# **Eelgrass Restoration and Biological Resources Implementation Work Plan**

## **Addendum 1**

**April 2010**

Prepared by:  
Grette Associates<sup>LLC</sup>  
Tacoma, WA

**BRIGHTWATER MARINE OUTFALL CORRIDOR**  
 Transplant Illustration

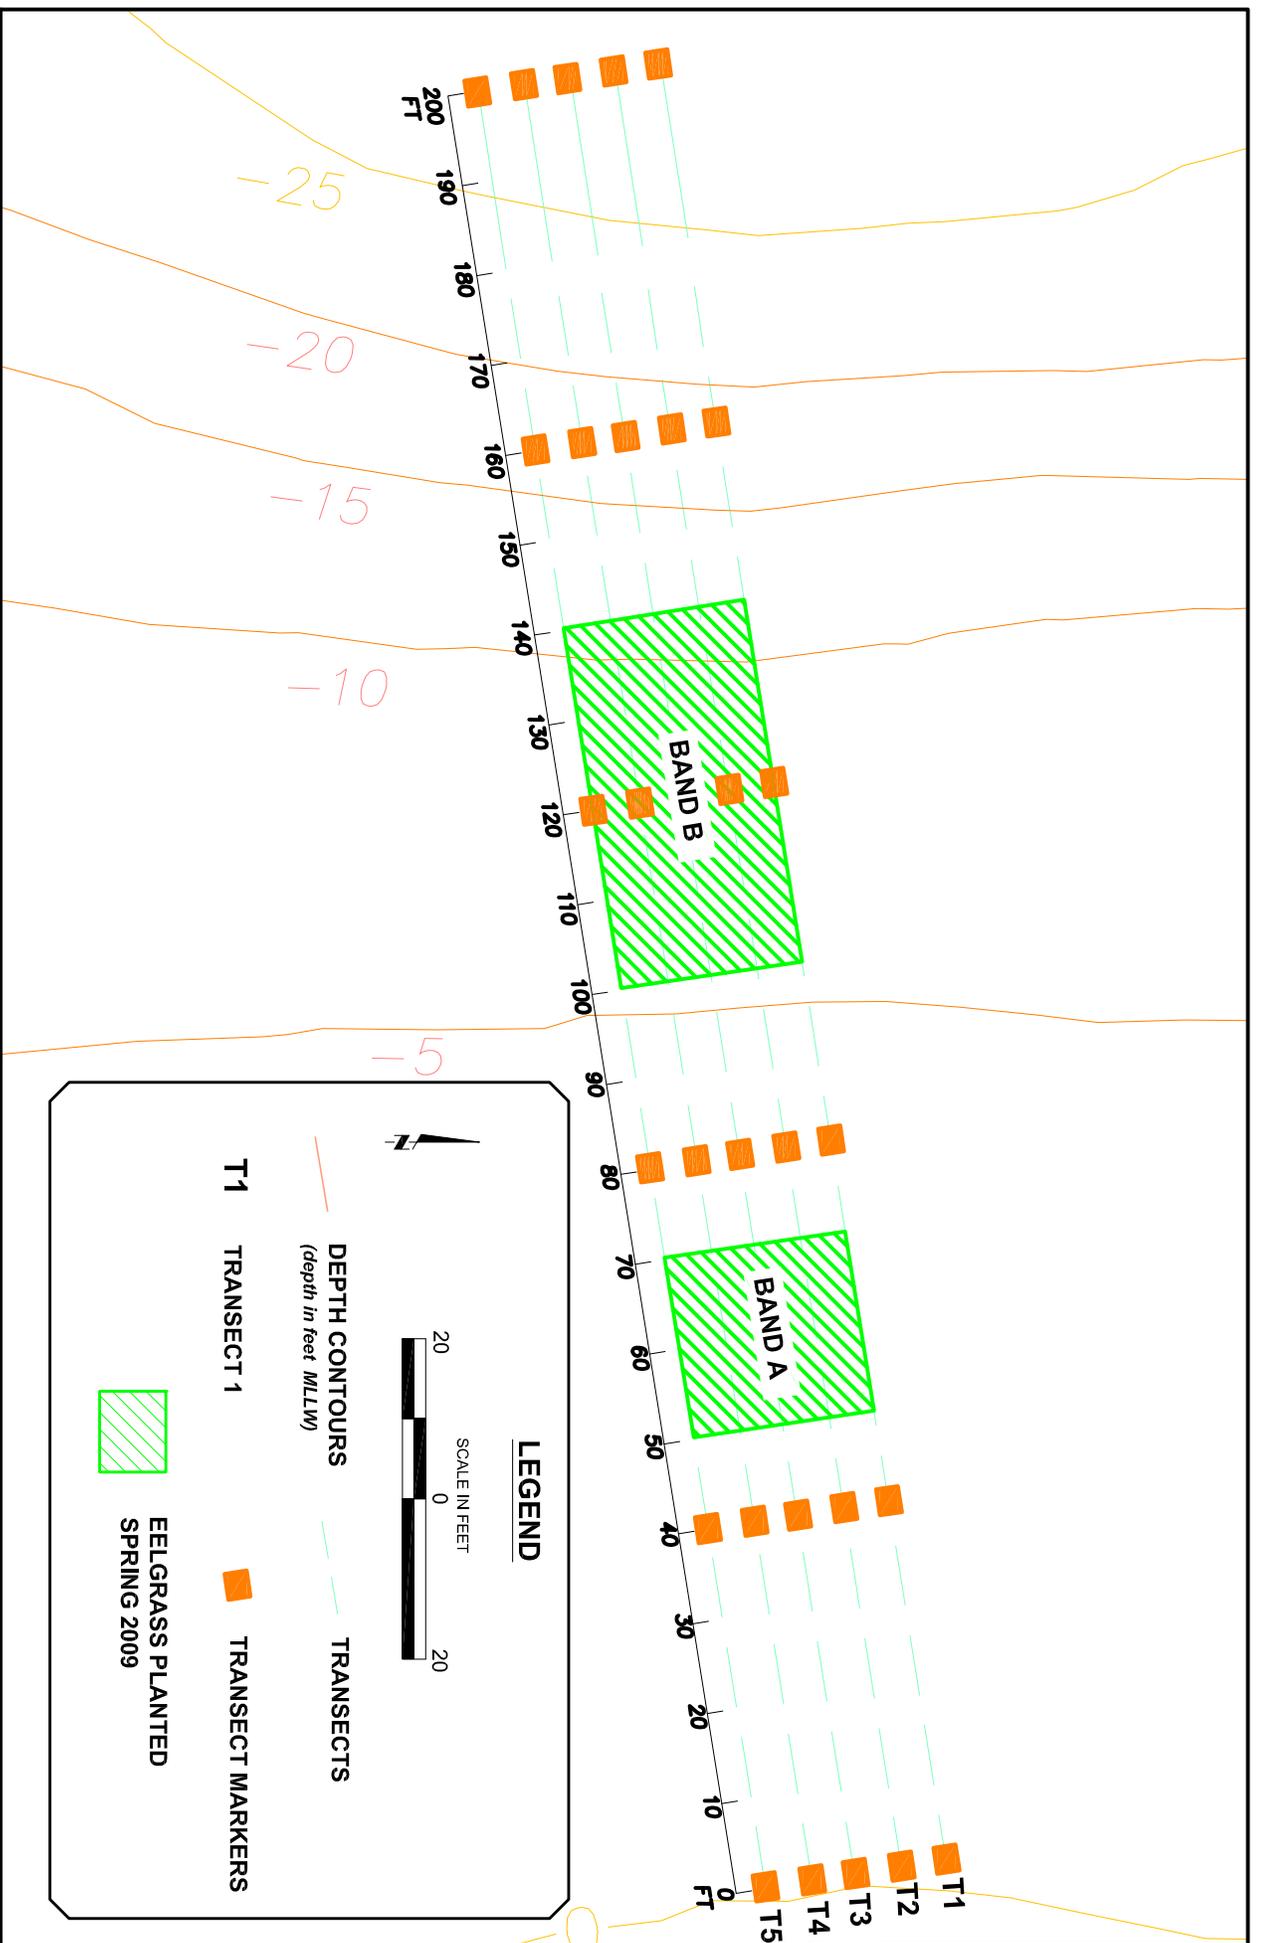
Transplanting of eelgrass was conducted only within the Corridor, and only within two bands of observed eelgrass (bands A and B are described in detail in Grette Associates 2009). Eelgrass was planted at a density of at minimum 56 shoots/m<sup>2</sup> in band A and at minimum 74 shoots/m<sup>2</sup> within band B, for a total number of between 10,000 and 16,000 plants planted. See the Eelgrass Transplant Report (Grette Associates 2009) for further details regarding the transplant effort.

Figure 1 of this Addendum is provided to illustrate the 2009 transplant effort in the Marine Outfall Corridor.

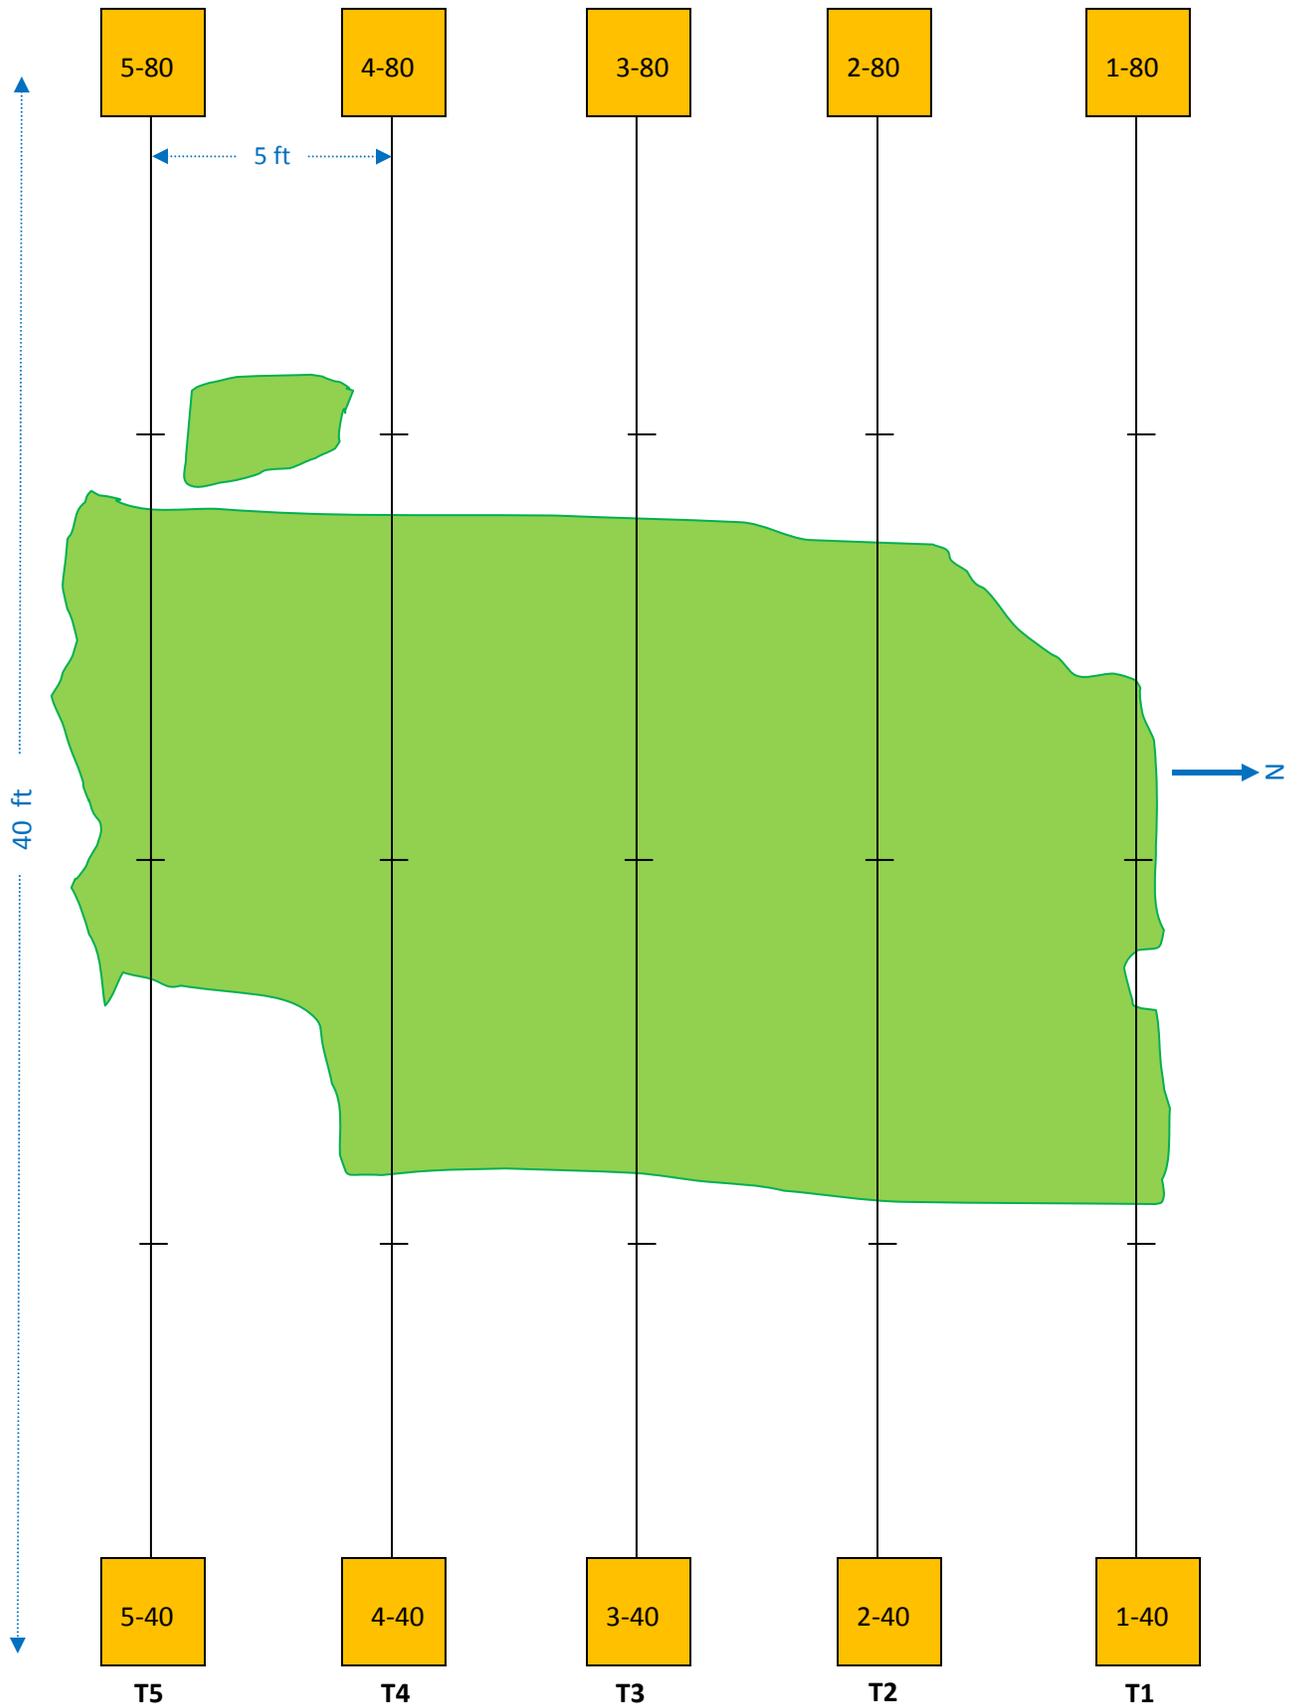
Text should also be added to describe delineation of eelgrass patches by divers in both the Outfall Corridor and the Reference Area. This method will be performed during post-construction monitoring efforts beginning in 2010, as noted in Section 6.3.1 of this Addendum. The following paragraphs should be added to the Work Plan in this section (3.3.1) to describe the new method:

*“Once all transect tapes have been deployed from 0 ft Mean Lower Low Water (MLLW) to the deep end of all 5 transects, divers will sketch an outline of the observed eelgrass patch edges. Specifically, divers will draw a map indicating where eelgrass extends laterally between Transects 1-5, and where eelgrass extends outside of the transects (north of T1 and south of T5), using the known distance between transects (5 ft) and the transect tape distance for reference.*

*Each data sheet will consist of either a 20-ft (width) by 40-ft (length) portion of the Outfall Corridor, or a 20-ft (width) by 50-ft (length) portion of the Reference Area, and each datasheet will span 2 sets of rebar. Divers will record the position of individual plants or clumps of plants outside the boundary of the contiguous eelgrass patch as well as the main patch body.”* An example datasheet can be found in Figure 2 of this Addendum.

Figure 2 of this Addendum is provided to illustrate the data sheet to be used during delineation of eelgrass patches within the Marine Outfall Corridor and the Reference Areas. This method will be used starting in 2010 during all subsequent post-construction surveys.
